D A V I S
S Q U A R E
A R C H I T E C T S

January 24, 2018

RE: Babcock Place
"Final" Architectural Peer Review Report

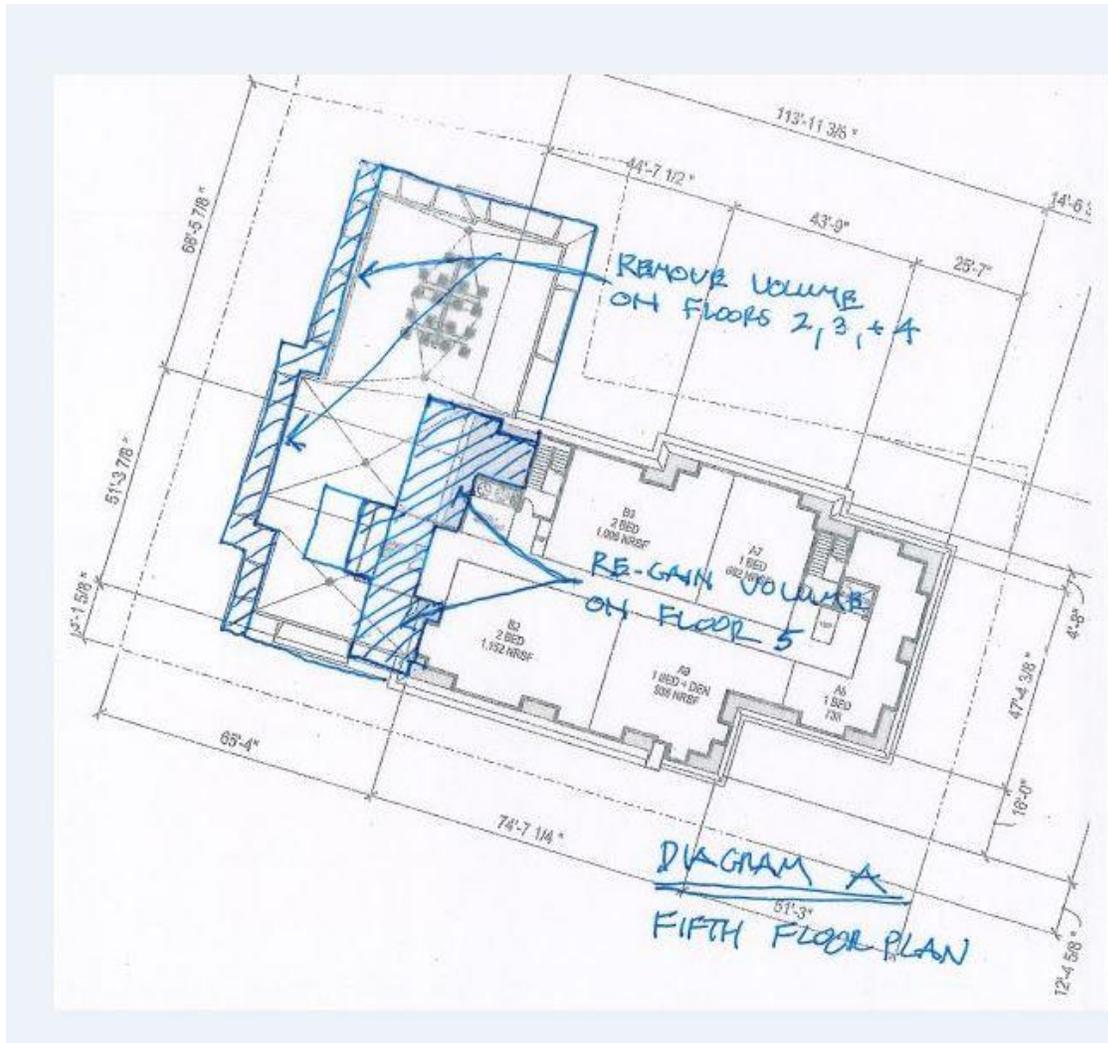
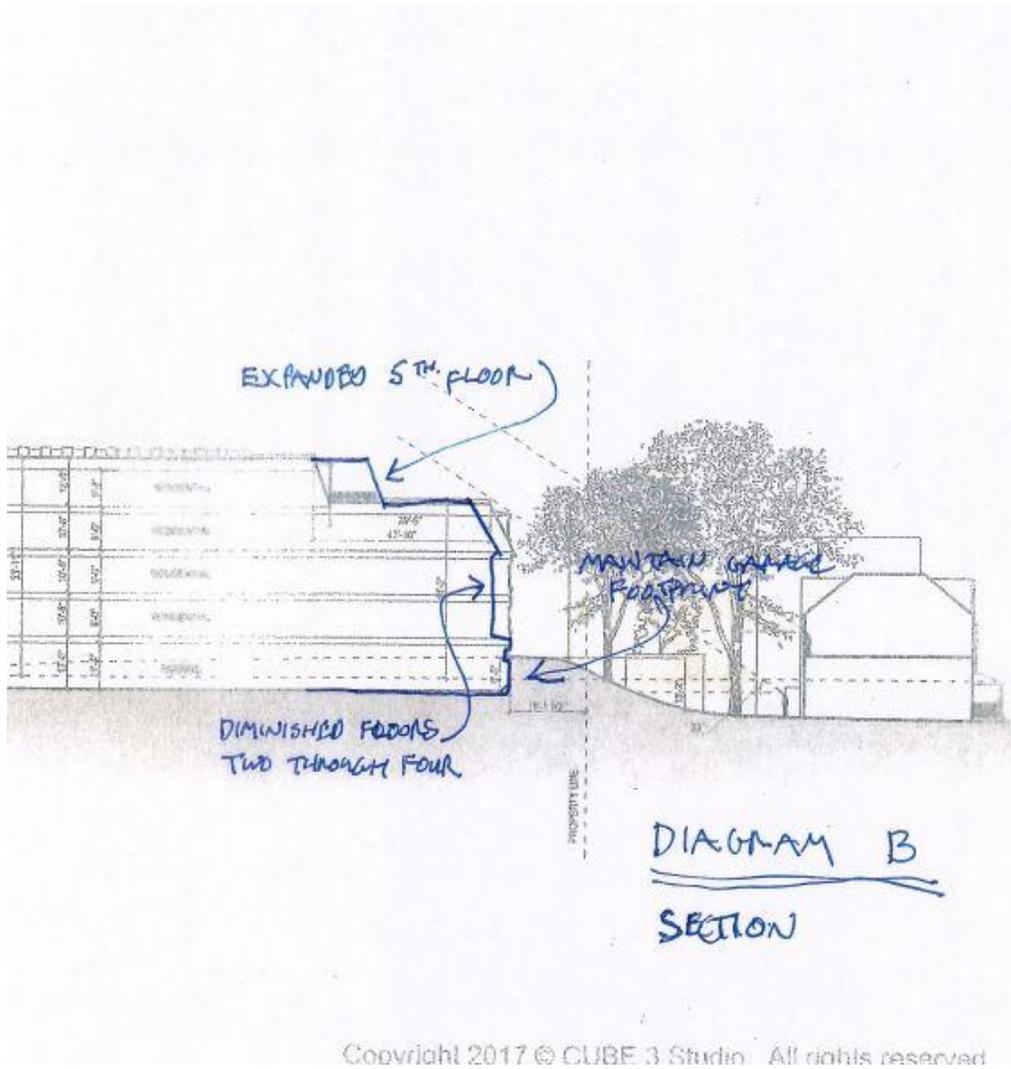
Recommendations 12/13/2017 plans: My initial conclusion after reviewing the December 13, 2017 drawings was that increasing setbacks of floors 2, 3, and 4 about 5 feet along the western elevation and the northern most end of the “ell” would make an improvement to the sense of the scale of the new structure and to the view of the open sky for the Stedman neighbors. There would also be a resultant diminution of shadow impact. In addition, more space would be provided for crown growth on new and existing trees. The same improvements would hold for the more distant neighbors to the north, but to a lesser degree given that they are further away from the new building and there is less grade change towards the north (see diagrams attached to this letter).

DIAGRAM C
LOADING AREA

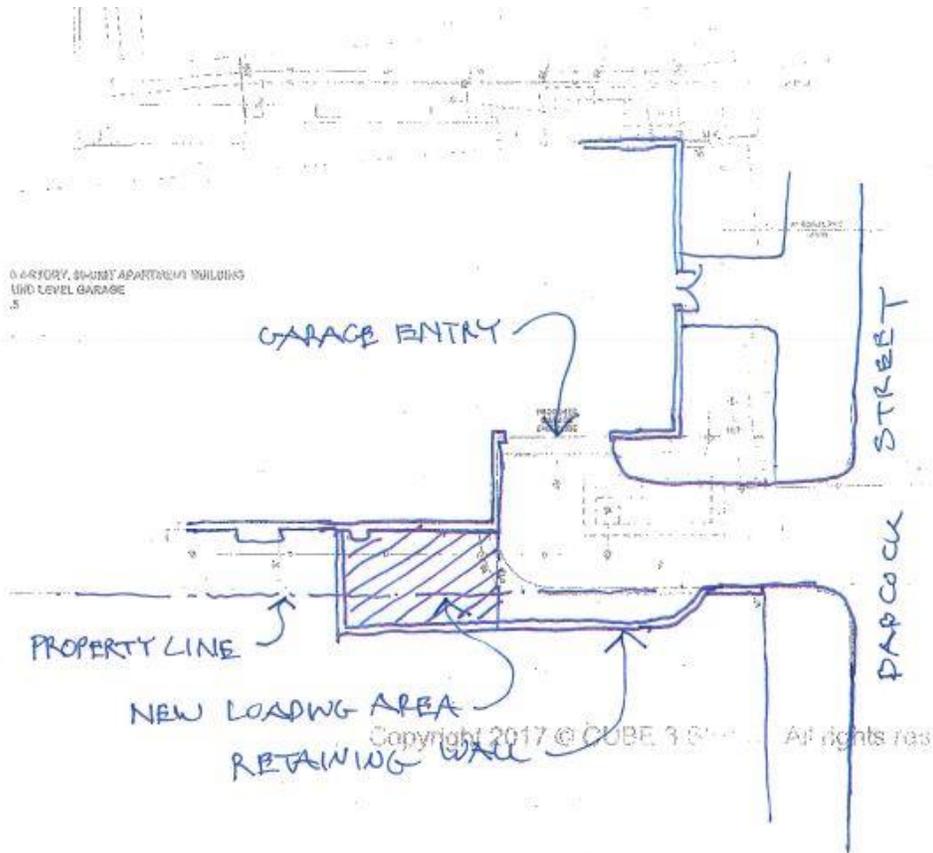
- Provision of details of several specific elevation components (garage doors, louvers, all material callouts on elevations, etc.).
- Consideration should be given to providing a parking/loading pad located as a continuation of the entry drive off of Babcock (see attached sketch). If the maneuvering area is increased across the southern property line, it would be possible to address concerns about inadequate turning radius into the garage. Increasing the width of the drive would encroach on 120 Babcock, and could require an easement (see Diagram C).
